# Access Compliance Report

## Public Rights-of-Way

### (Curb Ramps)

Intersection ID: N/A	Main Street: PAINTED_TRILLIUM_CT	Cross Street: LONGSPUR_DR	Location: SW
ADA ID: E7B12D2BC803	Ramp Type: BlendTrans2	Initial Pass/Fail: Fail	Overall Compliance: No
Severity Score: 12.5			
Codes/Mitigation Info/Possible Solution		Field Measurements/Component Compliance

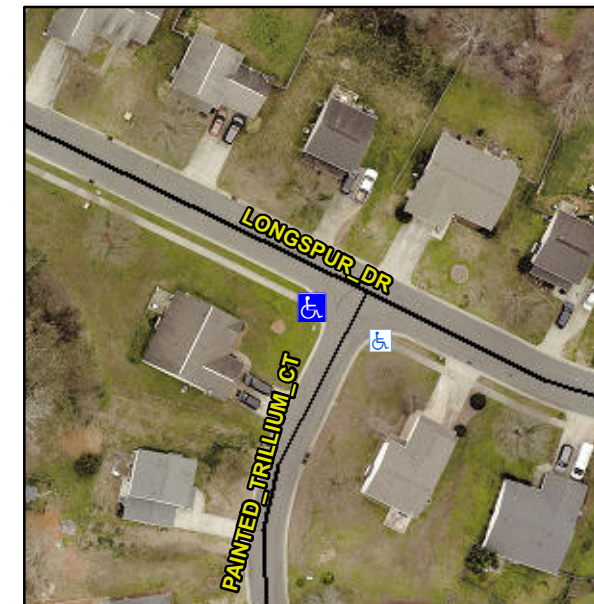
**R304.5.3**

Compliance	Description	Data	Compliance	Description	Data
N/A	Ramp Length (in)	47.0	Yes	BlendTrans Slope (%)	3.2
Yes	Ramp Width (in)	48.0	No	BlendTrans XSlope (%)	6.1
N/A	Flare Type LT	N/A	N/A	Flare Type RT	N/A
N/A	Flare Slope LT (%)	N/A	N/A	Flare Slope RT (%)	N/A
N/A	Flare Traversable LT?	N/A	N/A	Flare Traversable RT?	N/A
N/A	Landing Length (in)	N/A	N/A	DWS Provided?	N/A
N/A	Landing Width (in)	N/A	N/A	DWS Contrast?	N/A
N/A	Landing Slope (%)	N/A	N/A	DWS Length (in)	N/A
N/A	Landing X Slope (%)	N/A	N/A	DWS Full Width?	N/A
N/A	Landing Curb? (Y/N)	N/A	N/A	DWS Offset (in)	N/A
N/A	Shared Landing?	N/A			
N/A	Gutter Ponding?	N/A	N/A	Gutter Slope (%)	N/A
N/A	Gutter Lip Ht (in)	N/A	N/A	Gutter X Slope (%)	N/A
N/A	Painted X Walk1?	No	N/A	Painted X Walk2?	No
	X Walk 1 Direction	To SE		X Walk 2 Direction	To NE
	X Walk 1 Width (in)	N/A		X Walk 2 Width (in)	N/A
	X Walk 1 Slope (%)	5.1		X Walk 2 Slope (%)	0.8
	X Walk 1 X Slope (%)	1.2		X Walk 2 X Slope (%)	7.0

**Remove & Replace Curb Ramp With Two New Directional Ramps or Equivalent.**
